**Project # 24-45
HILLS' HILL MOUNTAIN BIKE FACILITY
ARLINGTON, MA**

ADDENDUM NO. 3

October 18, 2024

L200 - Site Preparation and Demolition.

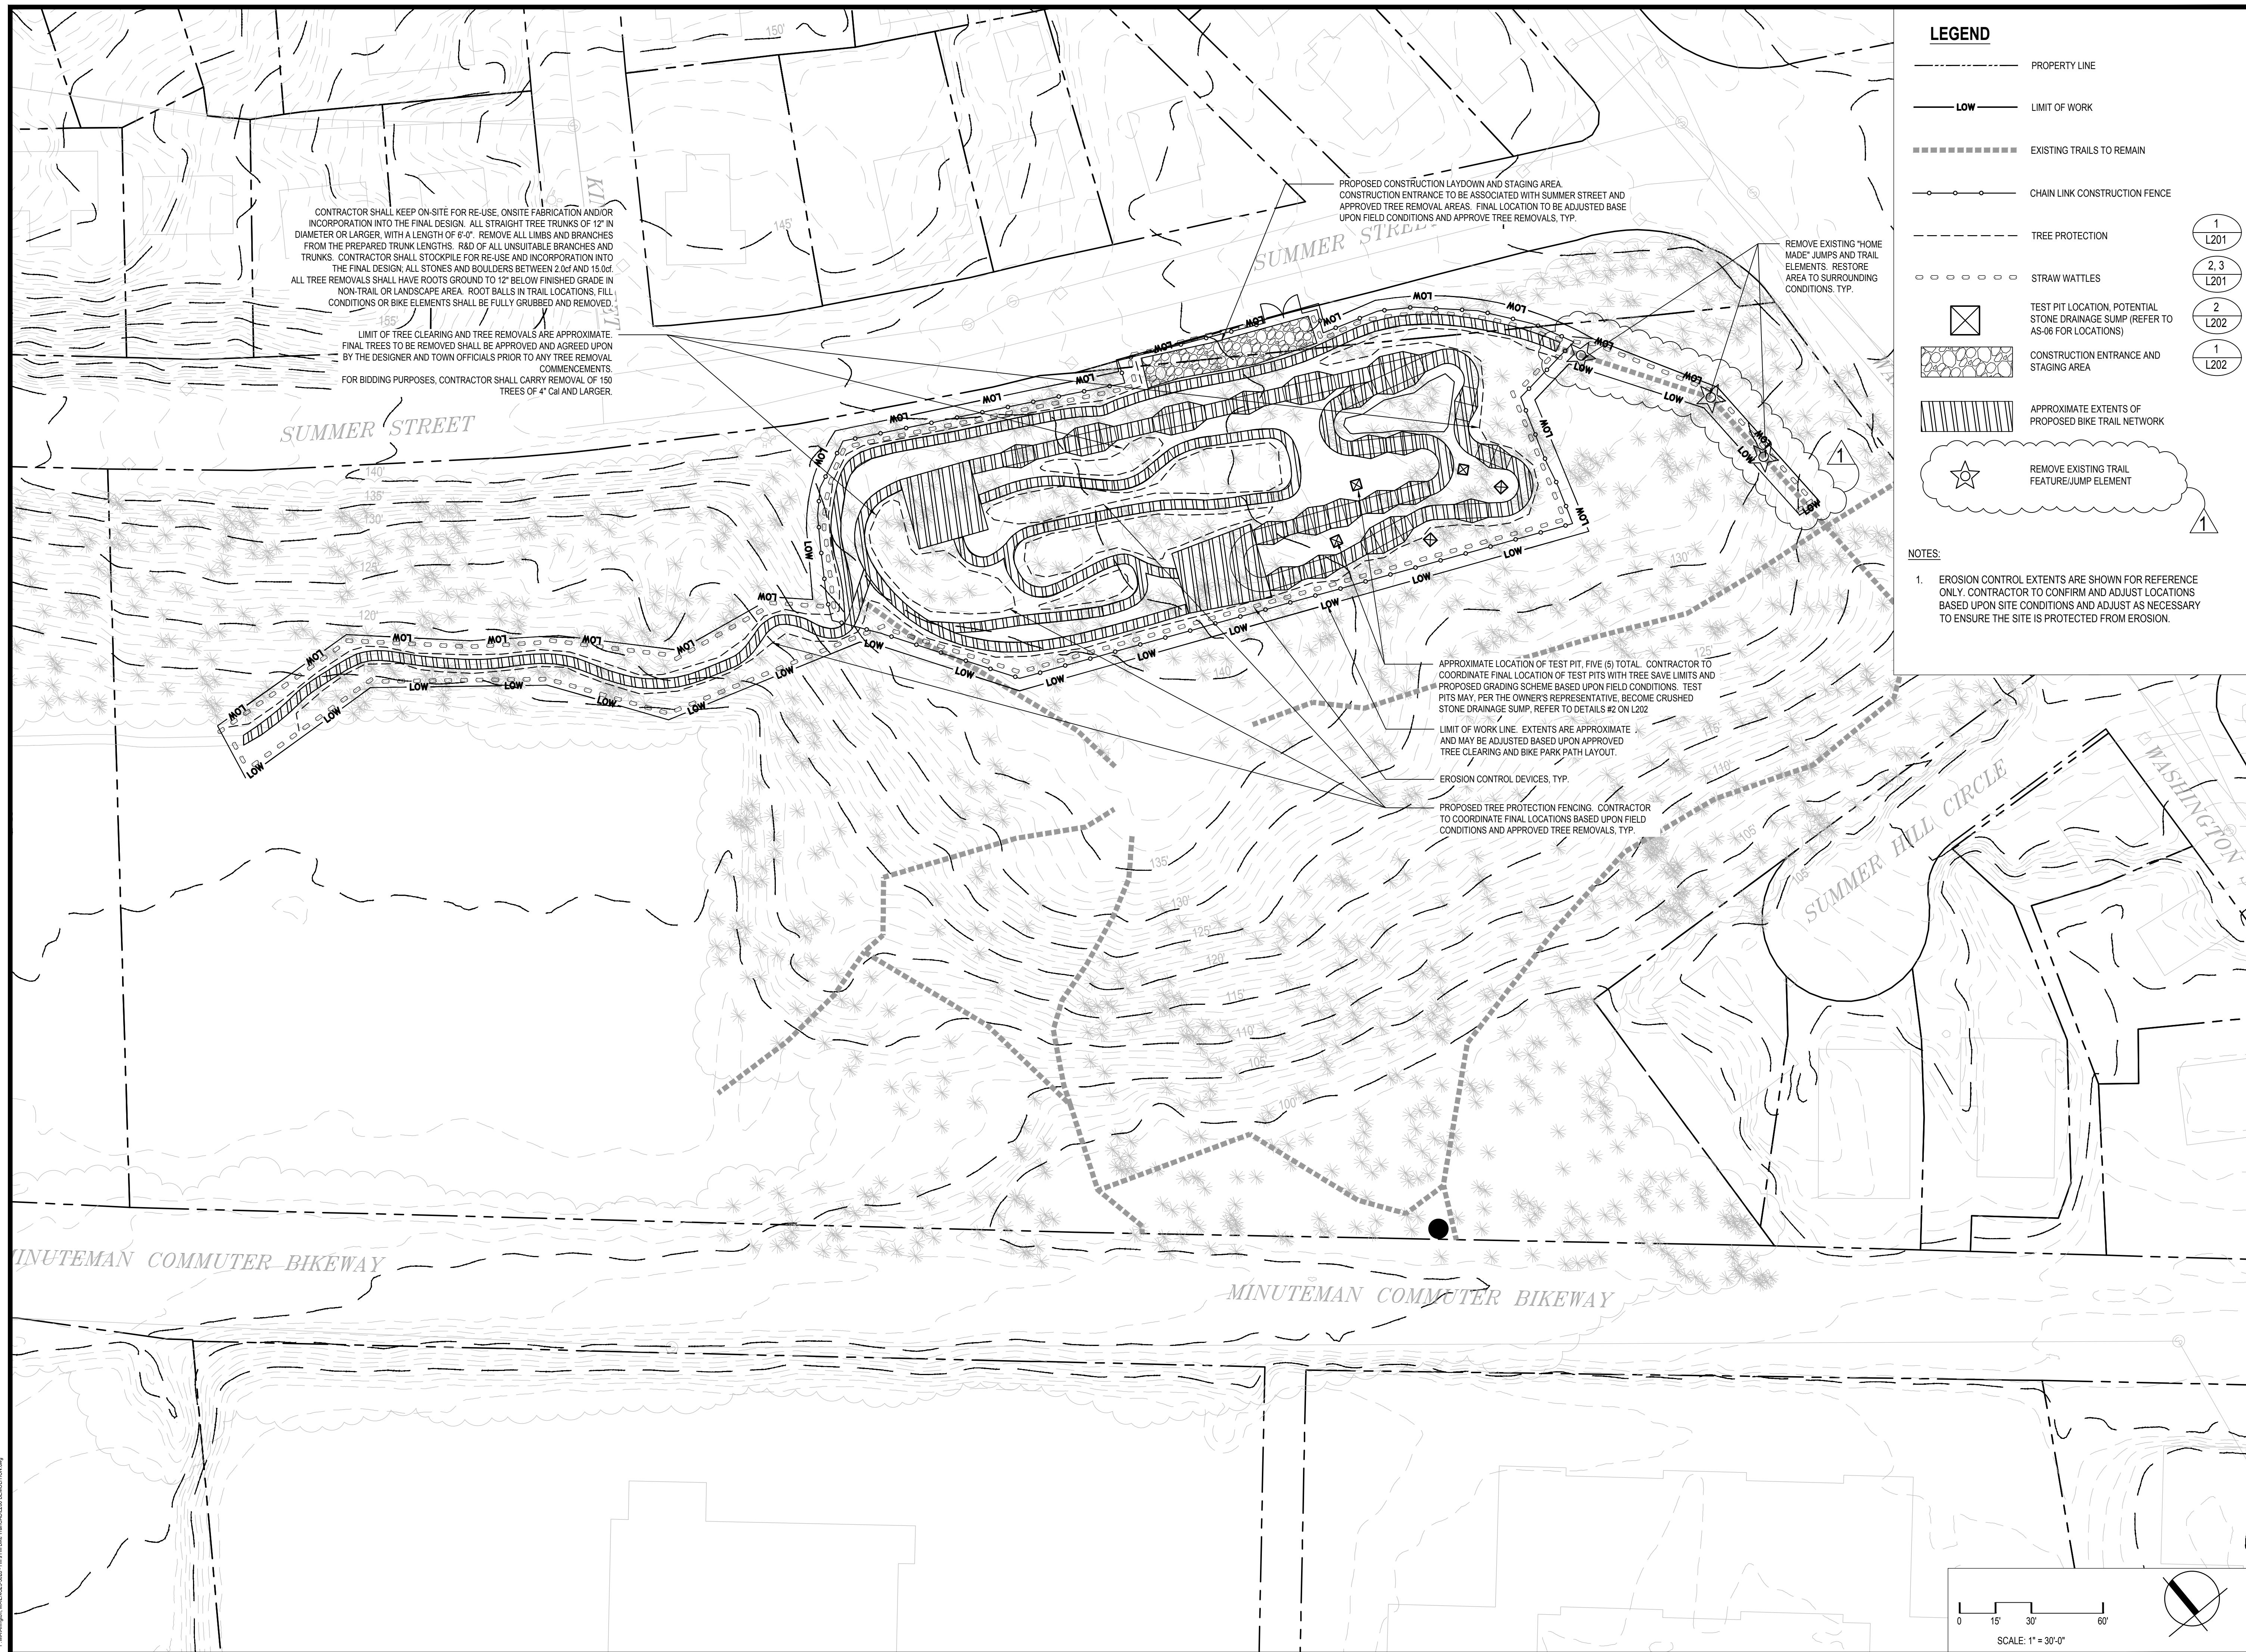
7. Add note to remove existing jumps and restore section of trail where they exist

W&S Response: Contractor shall own the complete removal and restoration of existing mountain bike trail features at locations indicated on Drawing L200 – SITE PREPARATION AND DEMOLITION PLAN, per attachment.

REMOVE EXISTING "HOME MADE" JUMPS AND TRAIL ELEMENTS. RESTORE AREA TO SURROUNDING CONDITIONS, TYP.
